RECEIPT DATE: 4/25/18 **ONSITE SEWAGE DISPOSAL SYSTEM**

PROPERTY ADDRESS: 12502 Triadelphia Road

**PLAN FOR SEPTIC & PUMP INSTALLATION**  
**THE WOODS AT TRIADDELPHIA**  
LOT 4  
TRIADDELPHIA WOODS PLAT #19925  
12502 Triadelphia Road

**To:** Zach Fisch  
**Cc:** Williams, Jeffrey  
**Subject:** RE: 12502 Triadelphia Rd.

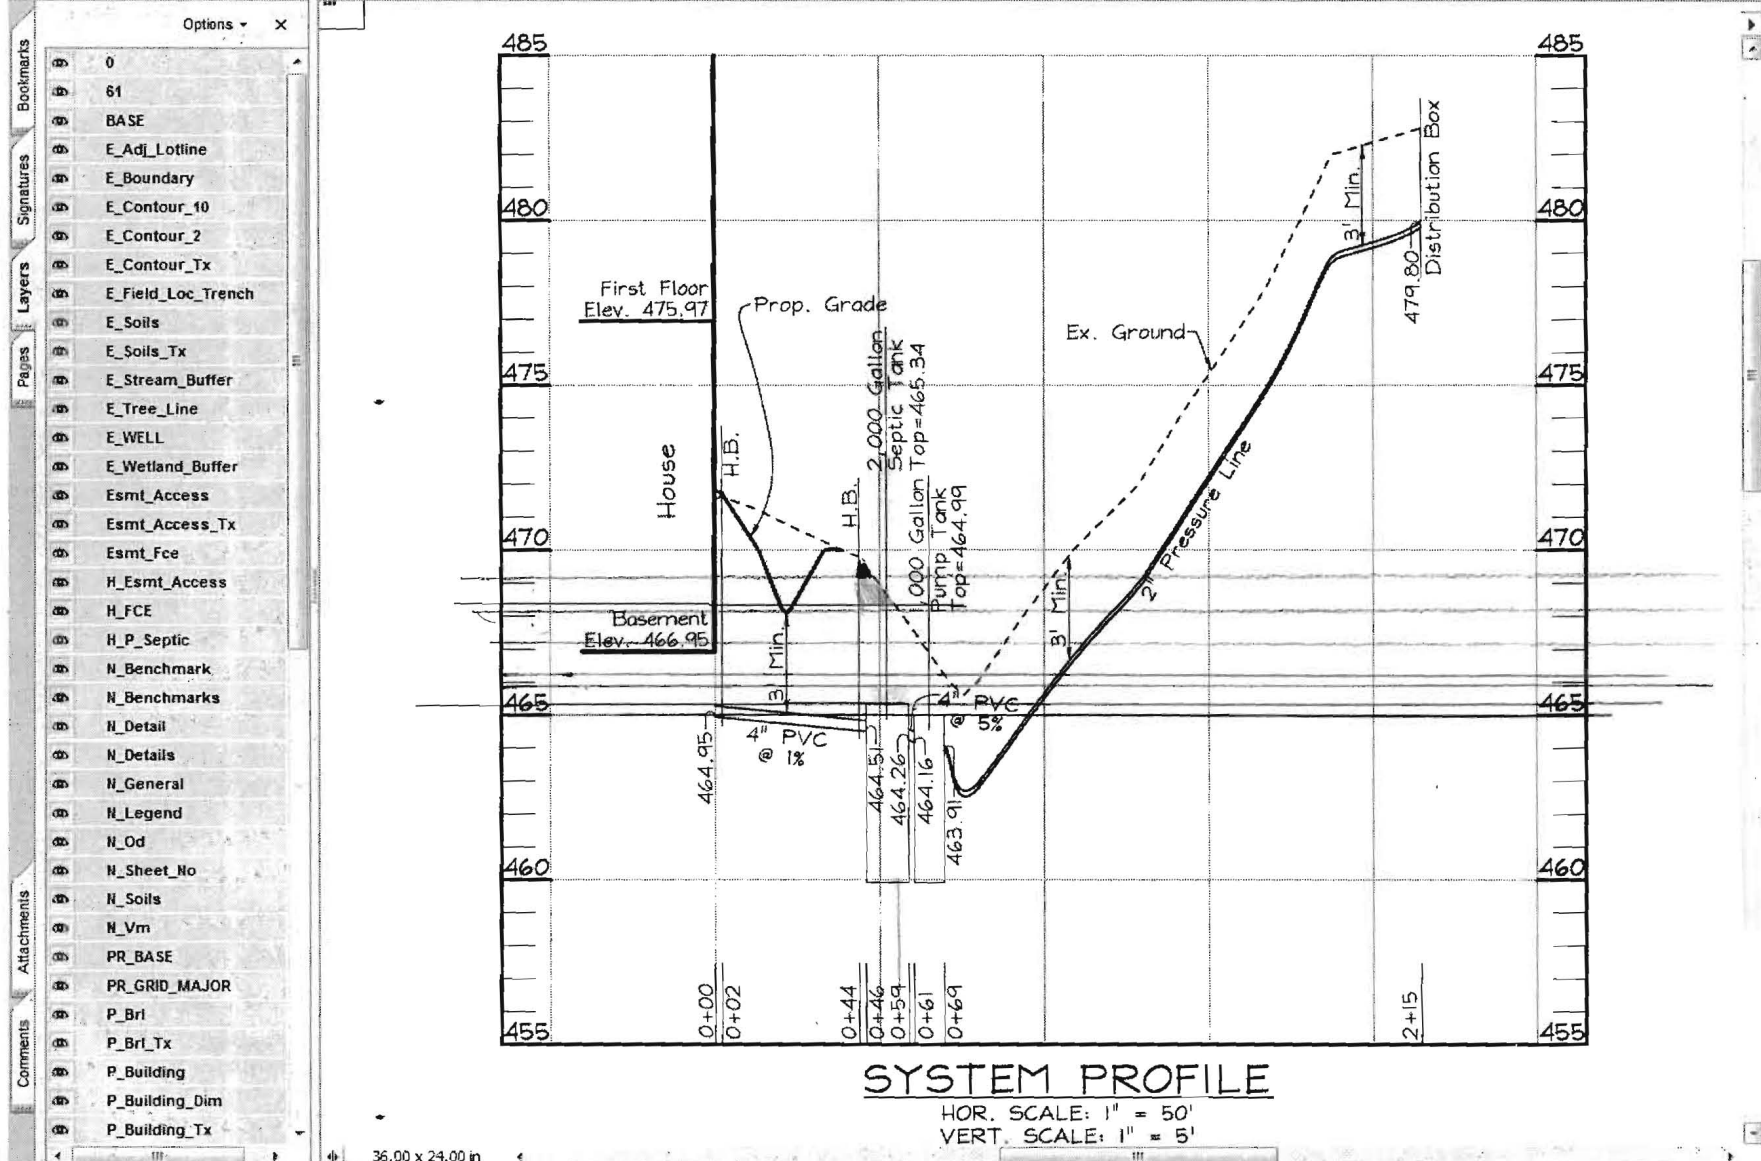
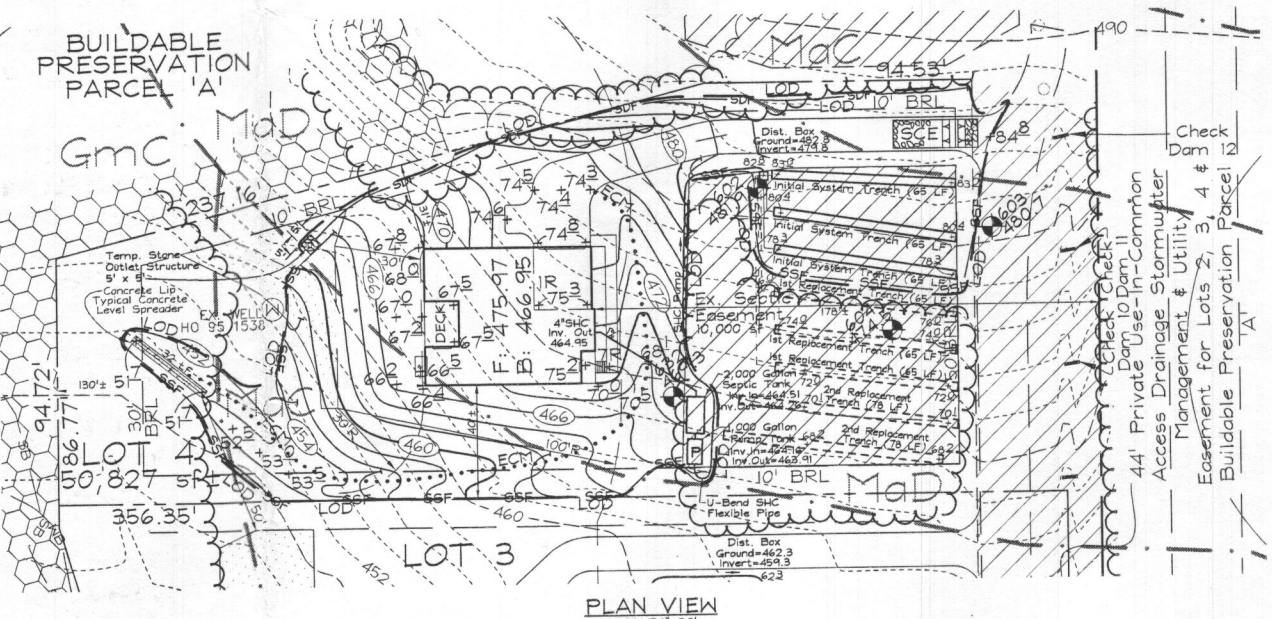
Zach,  
The plan shows the invert of the pipe at 464.95' not 465.95'. If you show the invert coming out at 465.95 and raise the septic tank accordingly there would be a very small amount of cover over 3' in which minimal grading may be permitted. With this a note stating, "Minimal grading over the septic tank is permitted by the Health Dept. in order to maintain 3ft or less ground cover," would need to be added. On the plan we would like you to show the minimal proposed grading. Other than that I still need to see a weep hole and proposed fittings shown on the pump tank. In addition the calculations for the pump tank still need to be shown. Please review my email from 8/28/17.

Zach,  
The issue with grading over the tanks is that they are inside of the SDA where grading cannot be allowed. Can the septic line coming from the house be raised from the 464.5' it is currently shown at? If that can be raised to 465.95 than grading over the tanks may not be necessary. As for the septic lines themselves they are not required to have 3' of cover. Let me know what you think.

I understand what you are saying about the area being disturbed either way however, even if the grading you are showing inside the SDA were allowed the structure of it concentrates storm/surface water directly on top of the septic tank. This is something we want to avoid if we are designing this system to last as long as possible. We have allowed you to place the tanks inside the SDA and to be 15' from the SWM swale (instead of the full 25'). Grading in slopes (some of it being >25%) that concentrate the surface water directly over the tanks defeats the purpose of moving them into the SDA in the first place. If you are unable to get 3' or less ground cover over the tanks they will have to be shown as traffic bearing.

Zach,  
If you are proposing the grade over the septic tank to not exceed 3ft it must be clearly shown on the plan. If you are proposing the grade over the septic tank to exceed 3ft a heavy load bearing tank must be clearly shown on the plan. Please refer to both of my emails sent on 10/10.

The note regarding the septic tank having 3ft or less ground cover is a general statement for everyone encase the plan has to change out in the field due to an unforeseen obstruction during installation. If we are purposely proposing a heavy load bearing tank it must be clearly shown on the plan as to avoid any confusion. If the electrical note was the only issue I would redline it in however, that is not the case.

I have reviewed the septic plan for Woods at Triadelphia, Lot 4. On the "System Profile" section of the plan it shows the septic tank with more than 3ft of cover. If a heavy load bearing tank is being proposed it must be shown on the plan. If a heavy load bearing tank is not being proposed the septic tank must have less than 3ft of cover shown on the plan. In addition, the note regarding electrical work is missing from the plan. Since this system involves a pump tank this note is required. Please refer to the OSDS requirements sheet sent on 8/28. If you have any questions let me know.

Spencer,  
Per your recommendation we revised the invert elevation at the house to 465.95. Please see revised plan and profile. Currently the health department is the last agency holding up the sign off of the building permit. Please approve so we can move on.

Spencer  
Attached is the revised plan.  
I added the electricians note and also limited the grade over the tanks to be at 3 feet.  
If it looks good I will drop off to you two full size copies.

The area disturbed within the SDA overlaps with the installation of the tank we have to disturb this area no matter what so the tank can be installed. We are back filling to a limit of 3 feet over the tank.

Lifting the pipe by 0.45 feet will not reduce the disturbed area within the SDA that needs to be disturbed for the tank installation.

Spencer,  
I would like to flatten the grade over the septic tank to maintain 3 feet of cover.  
Do you see a problem with this approach?

Sorry I missed the note regarding the licensed electrician. I am ok with you writing it in if you don't mind. There is a note on the plan stating that should the septic tank be more than 3 feet deep it has to be load bearing I thought that note should cover.
